Wake County Office Building
 12th & 14th Floor Upfit
 Raleigh, North Carolina
 March 6, 2025

ADDENDUM NO. 4
 Page 1

HUFFMAN ARCHITECTS, PA
 632 PERSHING ROAD
 RALEIGH, NORTH CAROLINA 27608
 PHONE (717) 644-1562

1 JAMB DETAIL - MILLWORK FRAME
 BD-01 3" = 1'-0"

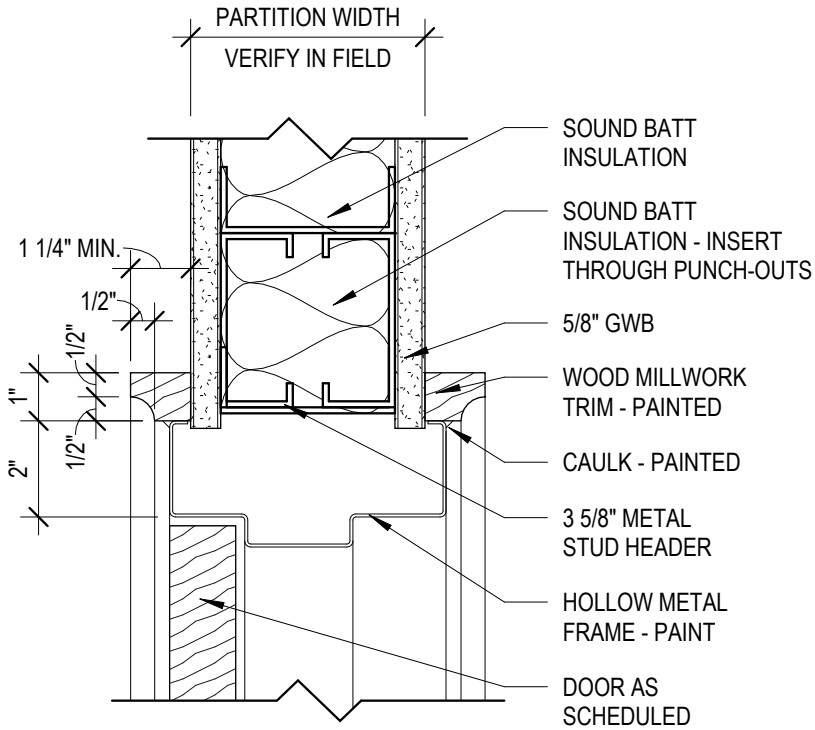
1. To avoid long lead times on the Curries 275 custom profile door frame (see Sheet A601), the General Contractor shall provide the detail included in the attached Bulletin Drawing BD-01 in lieu of the custom frame at all locations in the project.

2 HEAD DETAIL - MILLWORK FRAME
 BD-01 3" = 1'-0"
